Subject:
Buick City 761.61(c) Request – Addendum #1
RACER, Buick City, Flint, Michigan

This Addendum #1 to the 761.61 (c) Request for Risk-Based Cleanup Approval (dated May 23, 2023, Revised October 18, 2023) has been prepared for the RACER Buick City Site (Site) (EPA ID 005356712), located in Flint, Michigan. This submittal includes the following:

761.61(C) Memo - Corrected Figures

PCB AREA #5 DELINEATION POINTS

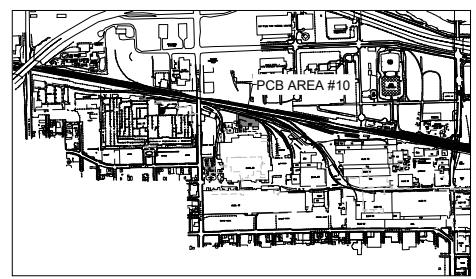
- PCB Memo #5 - Delineation locations TW-DH-RW-2-3 and TW-DH-RW-2-5 were replaced with the single location TW-DH-RW-2-6 in the restrictive covenant. The three locations are very closely located, were sampled at the same intervals, and the results were all less than 1 ppm. The figure was updated to reflect the restrictive covenant extent to eliminate any discrepancies.
- PCB Memo #10 – One of the databoxes on the figure is incorrect. A databox for TW-83/84-49-7 appears twice on the figure and the TW-83/84-49-6 databox is missing. The figure was edited to correct the databoxes as well as making a minor adjustment to the extent to draw the boundary through TW-83/84-49-6 to reflect the restrictive covenant to eliminate any discrepancies.
